Final Environmental Impact Report

Samoa Peninsula Land-based Aquaculture Project

County of Humboldt, Planning and Building Department
June 30, 2022

SCH#: 2021040532

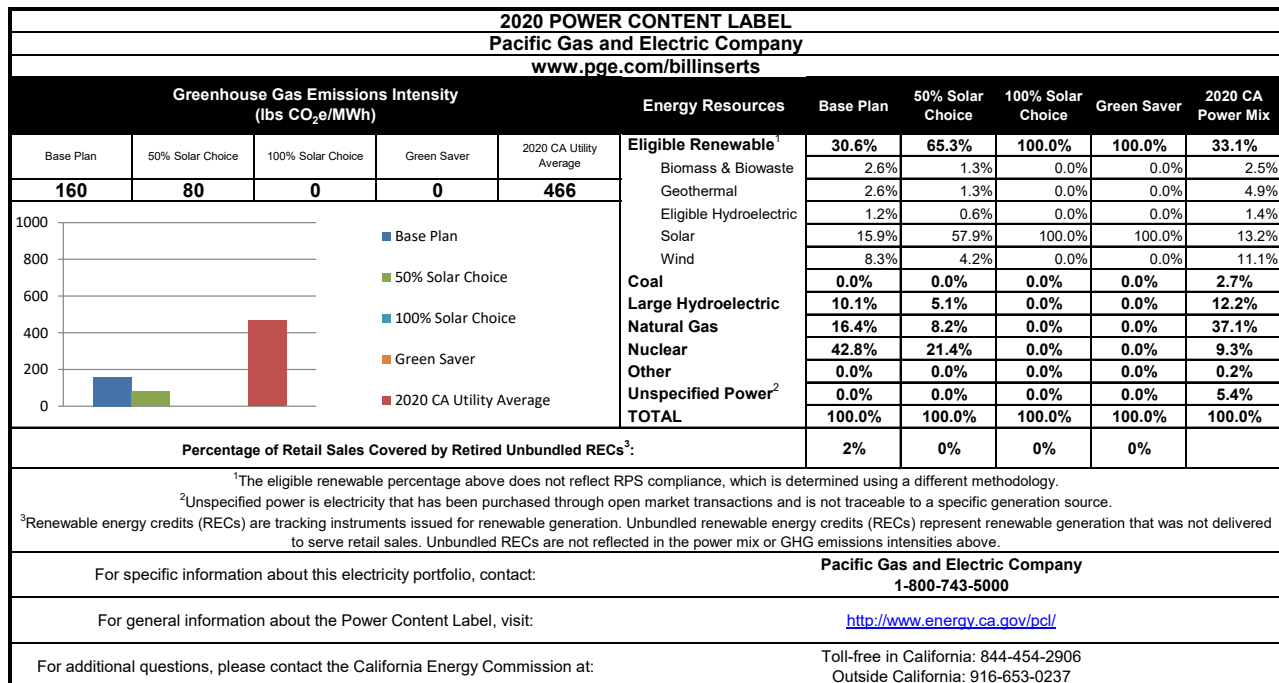
The DEIR for the Nordic Aquafarm reached a conclusion that there would be no significant greenhouse gas impacts. To do this the DEIR used the PG&E carbon intensity figure of 2.68 found at: https://www.pgecorp.com/corp_responsibility/reports/2021/pl02_climate_change.html

This anomalous figure for 2019 appeared to be an error, yet PG&E was saying it was verified by a third party. It also conflicted with more recent PG&E statements of greenhouse gases released per unit of electricity. In the graph below, PG&E lists its 2020 base emissions intensity at 160 lbs. of CO₂eq/MWh (a far cry from 2.68).

The explanation for why the PG&E carbon intensity figure for 2019 is wrong, and indeed will be for some years to come, is quite technical. So we want to be sure you are in a position to understand it and revise the DEIR by using the most recent carbon intensity figure from PG&E *prior* to application of the revised methodology. Under CEQA an EIR is required to accurately assess greenhouse gas emissions. The current DEIR does not fulfil this requirement.

Fig. A. Water temperatures at the Humboldt Bay Shore Station were several degrees higher than at the Trinidad Pier Station between May and November, 2017. Source: CeNCOOS.

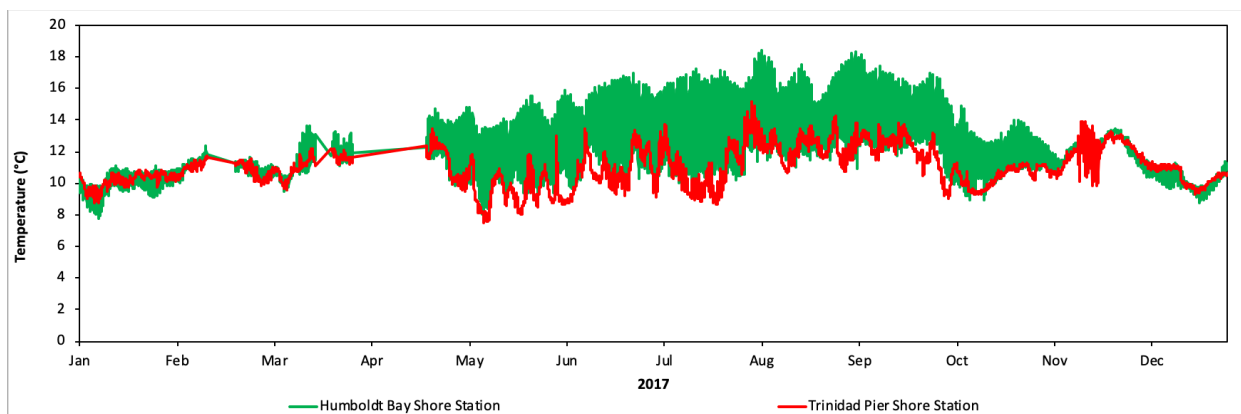
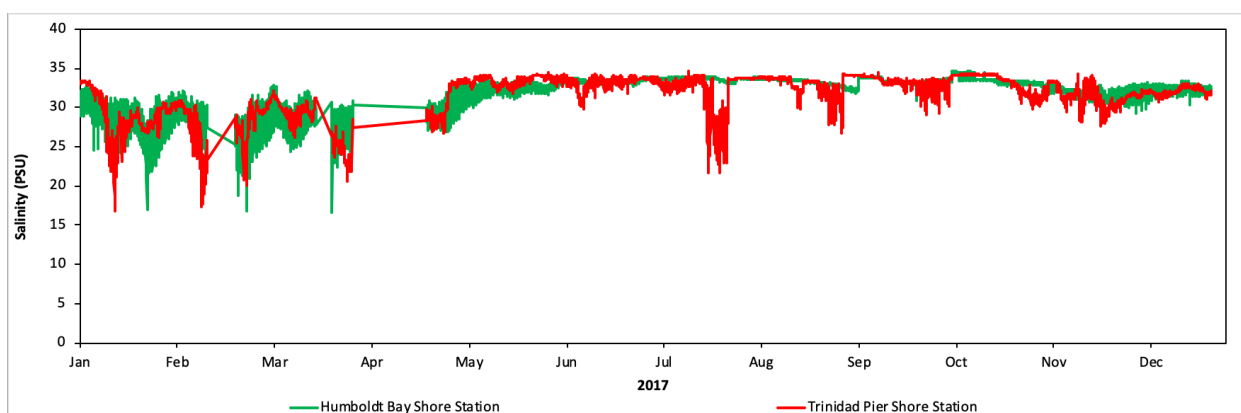
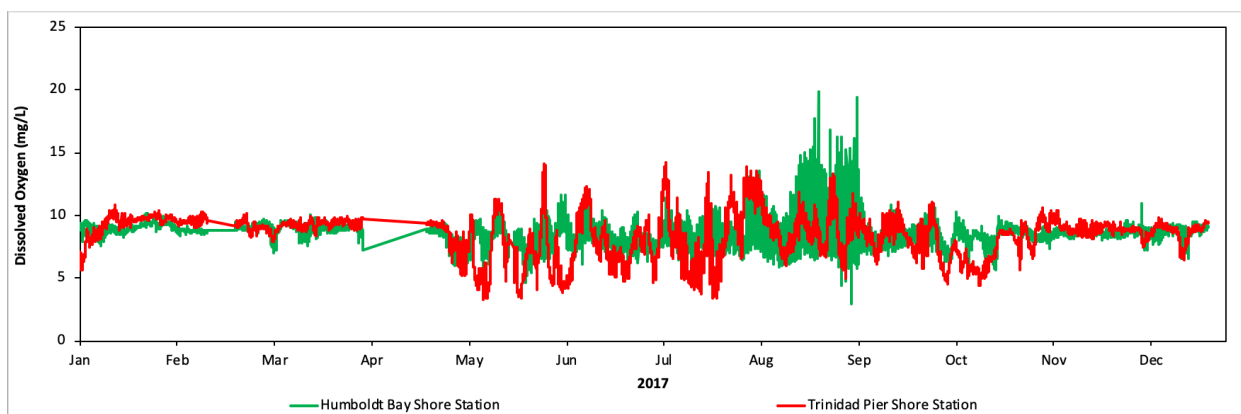
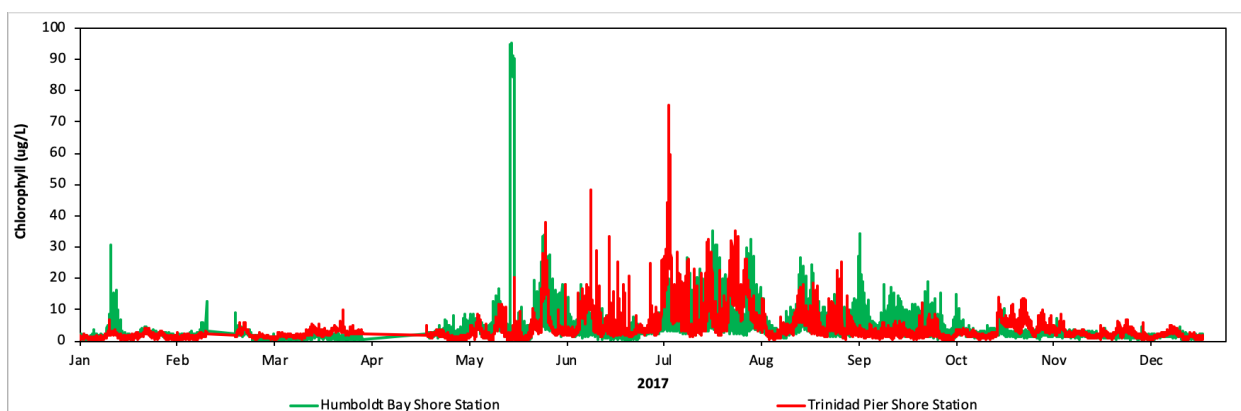
503-30
Cont.

Figure 3. Predicted salinity distribution on 11 January 2017 runoff event (upper vertical layer).

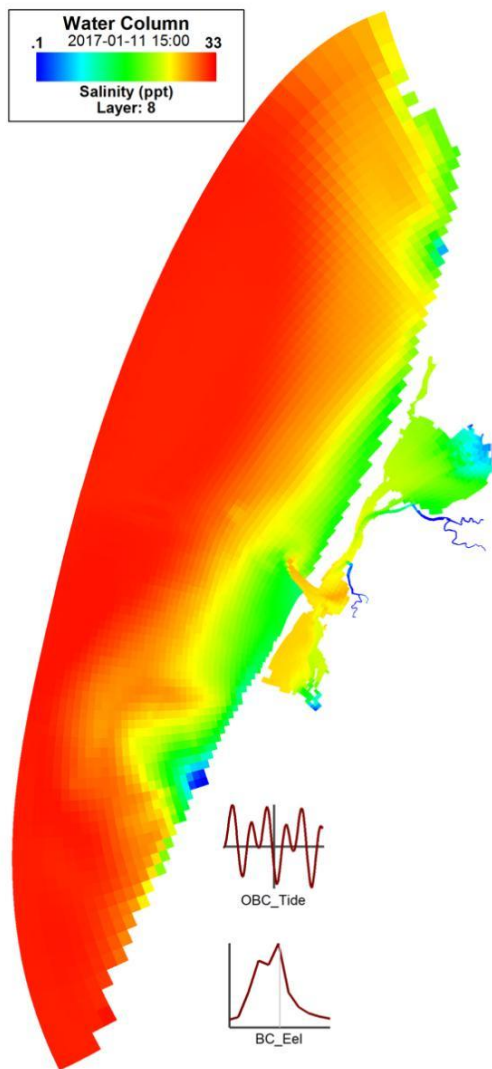
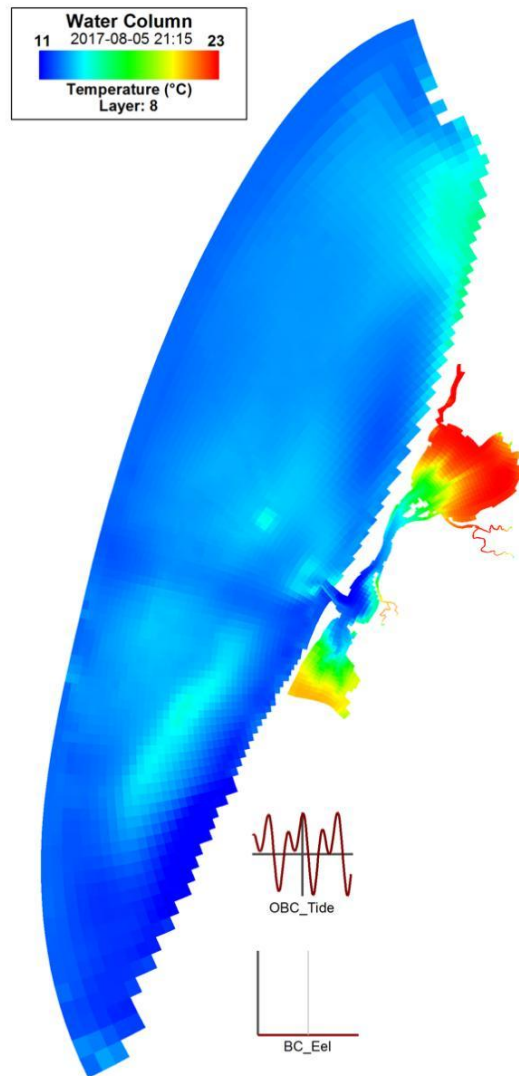
503-31
Cont.

Figure 4. Salmonids global warming potential (GWP) impacts (kg CO₂-e) and FCR based on production technology clusters.

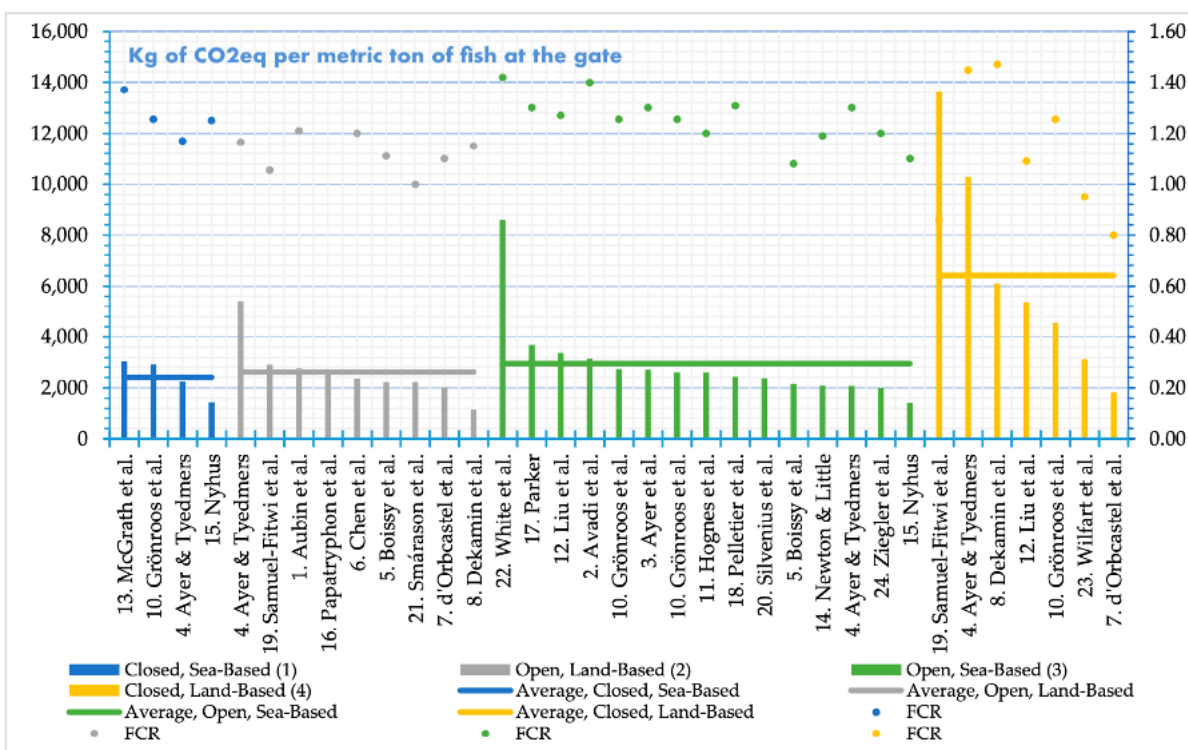
- In 2019,⁵³ a meta-analysis of LCA studies on salmonids (a much broader category than Atlantic Salmon) was performed with important conclusions. Twenty-four studies were found, nine dealing with Atlantic Salmon. The 24 studies were grouped into Open or Closed and Land vs Sea-based, forming four groups. Differences by production grouping are more important than differences by the fish type. The GHG impacts of land based recirculating systems are higher than other models. The three studies we presented above are in line with the averages shown in Figure 1 in the Appendix, with the LBCC-RAS studies showing in yellow. For 25,000 metric tons of fish from Nordic the metric tons of CO₂e would be 150,000 if we use the average.

Appendix Figure 2: Energy Intensity of Aquaculture Based on Feed

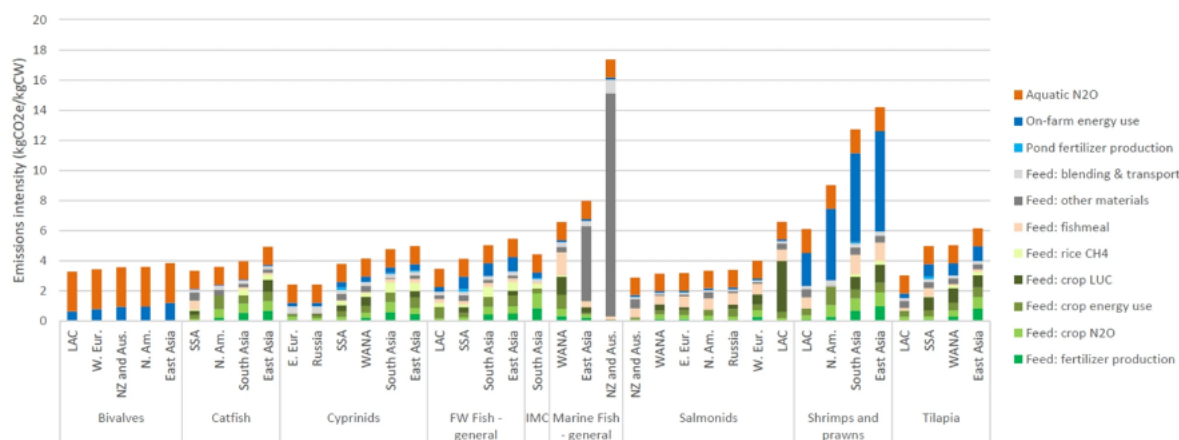
Production of crop feed materials (the green segments of Fig. 2) accounted for 39% of total aquaculture emissions. When the emissions arising from fishmeal production, feed blending and transport are added, feed production accounts for 57% of emissions.... For most of the finfish, the EI [Emissions intensity] lies between 4 and 6 kg CO₂e/kg CW (carcass weight, i.e. per kg of edible flesh) at the farm gate....[T]he carnivorous salmonids have more emissions associated with fishmeal and higher crop land use change (LUC) emissions (arising from soybean production), reflecting their higher protein rations.⁵⁸

With the production amount from Nordic and the energy intensity found in the above study, the range in GHG emissions annually would be between 100,000 and 162,000 MT CO₂e. Here is the conclusion of the study with regard to commercial fish food. The Figure 2 referred to can be found in the Appendix to this document.

The importance of feed is clear in Fig. 2 for all fed species. However, feed composition is constantly changing as nutritional knowledge and its application develop in response to commercial demand. This study was based on regional assumptions of feed formulations and raw material origins for the main species in the key regions. Data for this was obtained from a variety of sources (see “Methods”) and updated in light of discussions

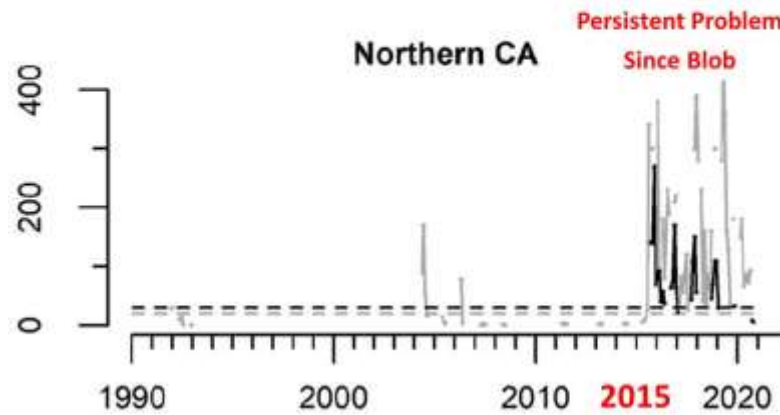
NOAA maps show “the Blob” setting up in 2014, but ocean warming recurring in 2019

In addition, the Pacific Decadal Oscillation Cycle that has driven ocean productivity and wet and dry conditions on land has broken down. It looks like persistent warming is likely, which elevates the risk of algae blooms.

NOAA (2020) chart from California Current Report. Red annotation added.

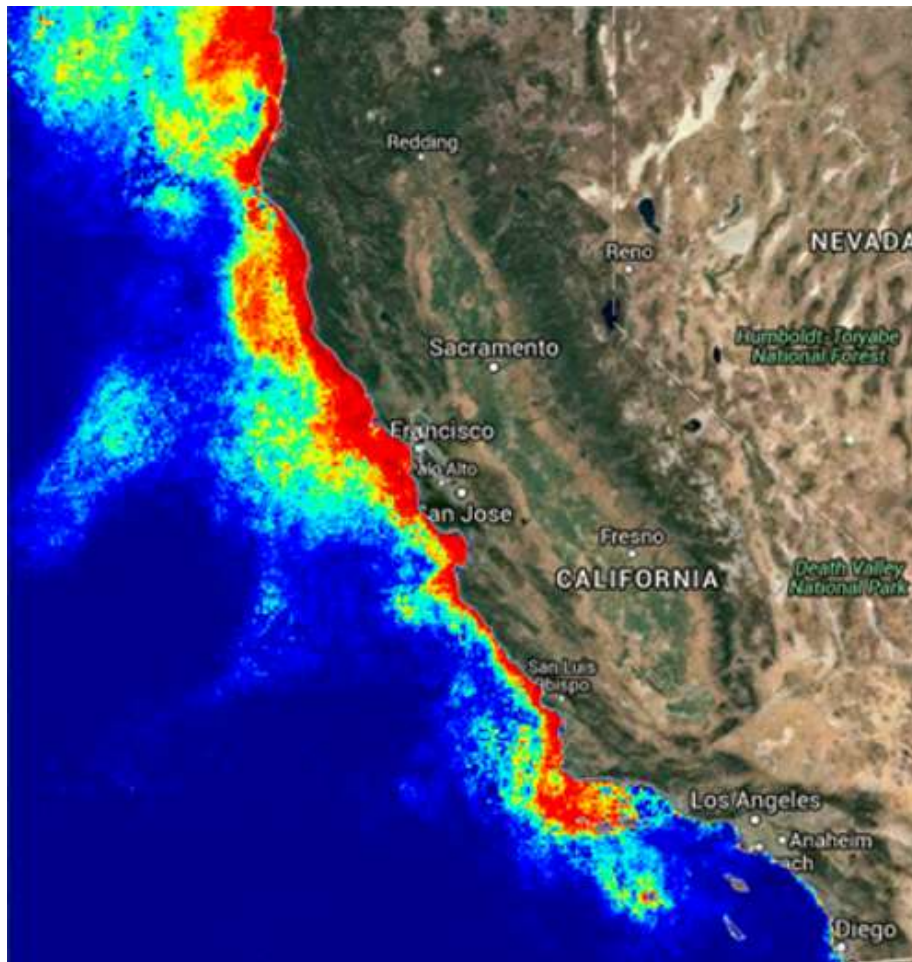
During the 2015 period of ocean warming HABs occurred along the entire California coast, and it is likely that this will occur periodically in the future.

UC Santa Cruz forecasting model of harmful algal bloom conditions along the California coast shows the bloom of toxic *Pseudo-nitzschia* diatoms (red) covering the entire coastline north of Santa Barbara in August 2015.

Figure 1. Breakdown of fish feed components by Skretting, a manufacturer used by NAF.

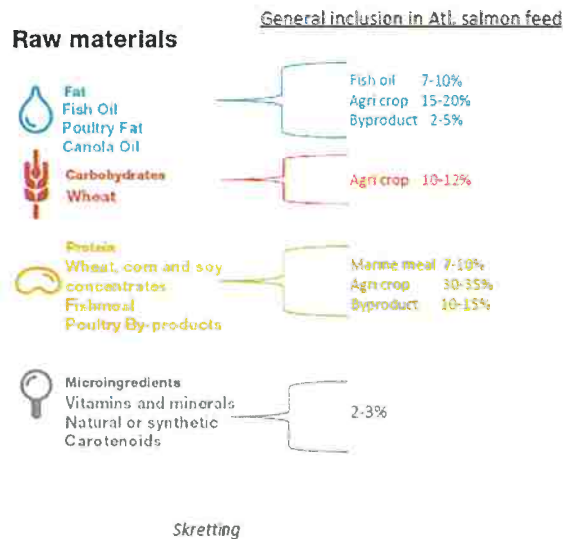
In my earlier comment letters, I brought to your attention the issue that use of poultry byproducts can pose a risk to human health. I raised the particular concern that antibiotic resistant *Escherichia coli* and *Staphylococcus aureus* could pose a risk to swimmers and surfers. I also pointed out that antibiotic resistance in RAS systems, such as in NAF's Project design, is an emerging disease threat (Liu *et al.* 2020), and that antibiotic-resistant bacteria from the Project that enters the facility via fish feed may put workers, recreational ocean-water users, and fishermen at risk.

The DEIR does not include any mention of antibiotic-resistant bacteria. It does not address any of the antibiotic-resistant bacteria associated with aquafarming that have been found to cause illness and death. At a very minimum, the DEIR should include a monitoring plan for antibiotic resistant strains of *E. coli*, *Staphylococcus aureus*, *Vibrio vulnificus*, and *Vibrio parahaemolyticus*. The monitoring plan should include remediation and reporting. Such a plan would be used to reduce pathogen exposure and risk to surfers and other beachgoers, truckers hauling the sewage solids, factory workers, workers at the end-point composting facilities, commercial fishermen, and tourists.

Figure 2. Monthly maximum domoic acid concentration (ppm) in razor clams (gray) and Dungeness crab viscera (black) through 2020.) Figure 3.4.1 from the 2021 *California Current Integrated Ecosystem Assessment (CCIEA) California Current Ecosystem Status Report*.

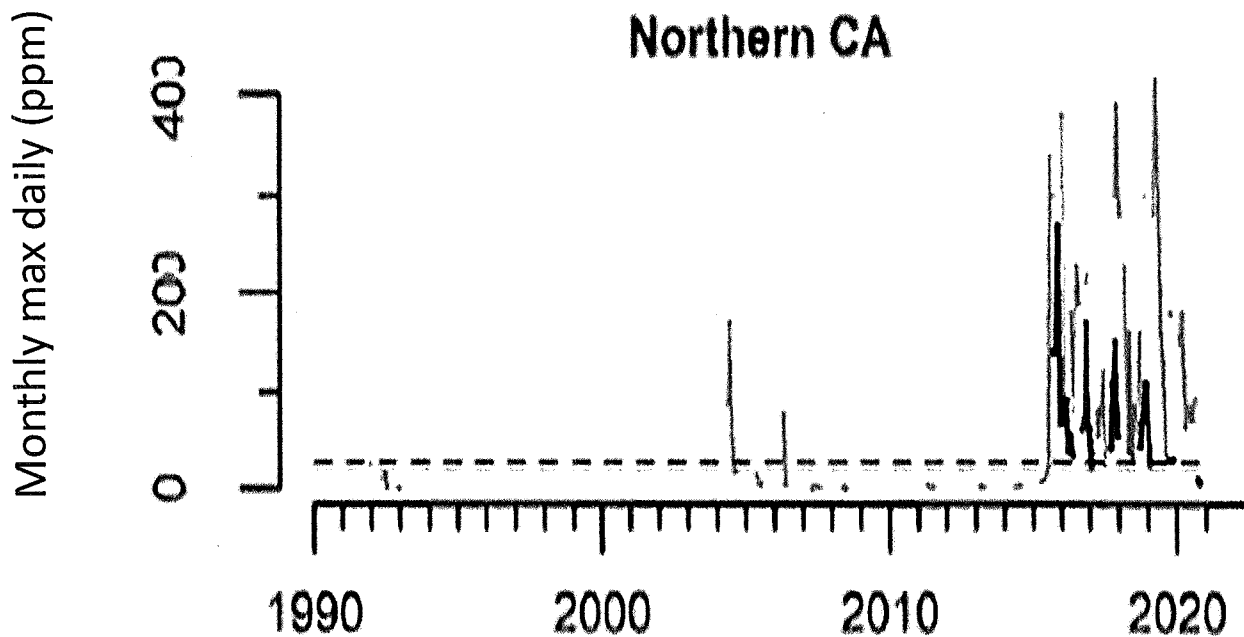
above ambient. It is well-established scientifically that the combination of warm water and nutrients is a recipe for algal blooms. When those algal blooms include toxic species or species that release toxic substances, such as *Pseudo-nitzschia*, organisms in the environment could be harmed, injured, or killed. The DEIR's conclusion that "the risk of increase in domoic acid producing diatoms is very low" (page 3.3-27) does not take into consideration the fact that *Pseudo-nitzschia* continues to be present in northern coastal California waters (Figure 2), and that *Pseudo-nitzschia* responds very rapidly to localized warming and nutrient loading. Although it is true that domoic acid proliferation is known to be associated with large-scale climate events, the continuing presence of *Pseudo-nitzschia* in coastal waters puts the marine ecosystem at risk from a domoic acid events. Figure 2 shows that lesser domoic acid events have occurred since the major event in 2016.

The currently low, anthropogenic nitrogen fluxes in the vicinity of the outfall pipe (page 3.3-29) prior to Project operation is not a good argument for lack of marine effects from nitrogen loading. Claiming that there is "little evidence that anthropogenic nutrient
